[Federal Register Volume 79, Number 118 (Thursday, June 19, 2014)]
[Rules and Regulations]
[Pages 35037-35041]
From the Federal Register Online via the Government Printing Office [www.gpo.gov]
[FR Doc No: 2014-13835]

[Docket No. FAA-2012-0415; Directorate Identifier 2008-SW-065-AD; Amendment 39-17865; AD 2014-12-04]

Airworthiness Directives; Bell Helicopter Textron, Inc. (BHTI) Helicopters

ACTION: Final rule.

Figure 1 to Paragraphs (f)(2)(ii) and (f)(4)(ii)
Inspection of Main Rotor Hub Grip Tangs

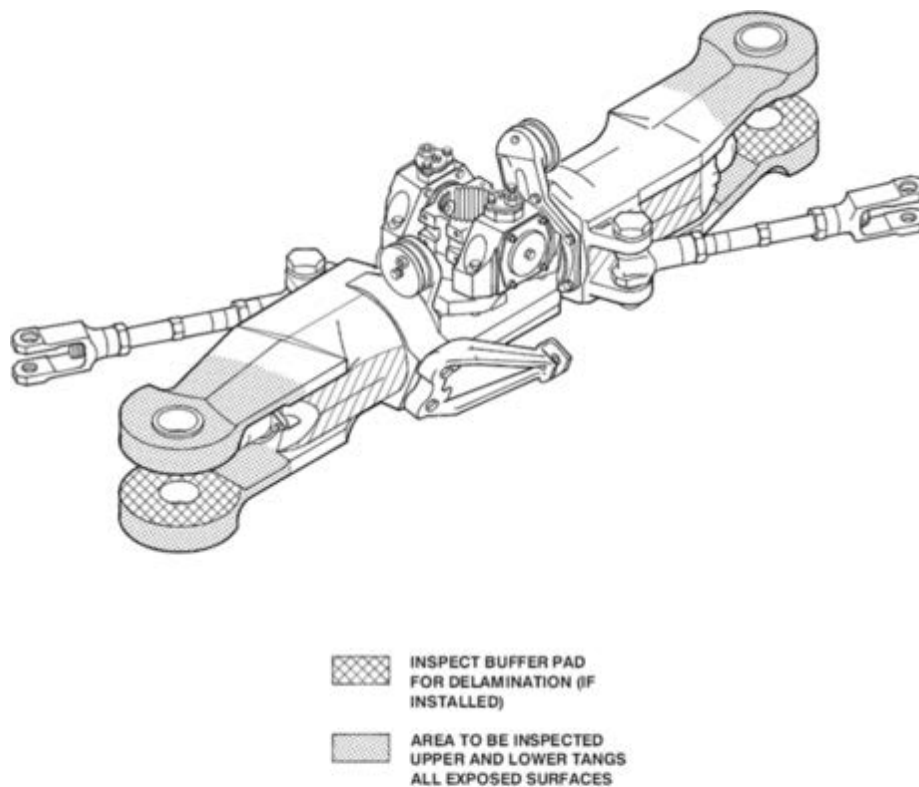
(ii) Using a 10-power or higher magnifying glass, visually inspect the exposed surfaces of the upper and lower tangs of each grip for a crack. Pay particular attention to the lower surface of each lower grip tang from the main rotor blade bolt-bushing flange to the leading and trailing edge of each grip tang as depicted in Figure 1 to Paragraphs (f)(2)(ii) and (f)(4)(ii) of this AD.

- (i) Remove each main rotor blade, and
- (ii) Inspect each grip buffer pad on the inner surfaces of each grip tang for delamination as depicted in Figure 1 to Paragraphs (f)(2)(ii) and (f)(4)(ii) of this AD. If there is any delamination, remove the buffer pad and inspect the grip surface for corrosion or other damage.
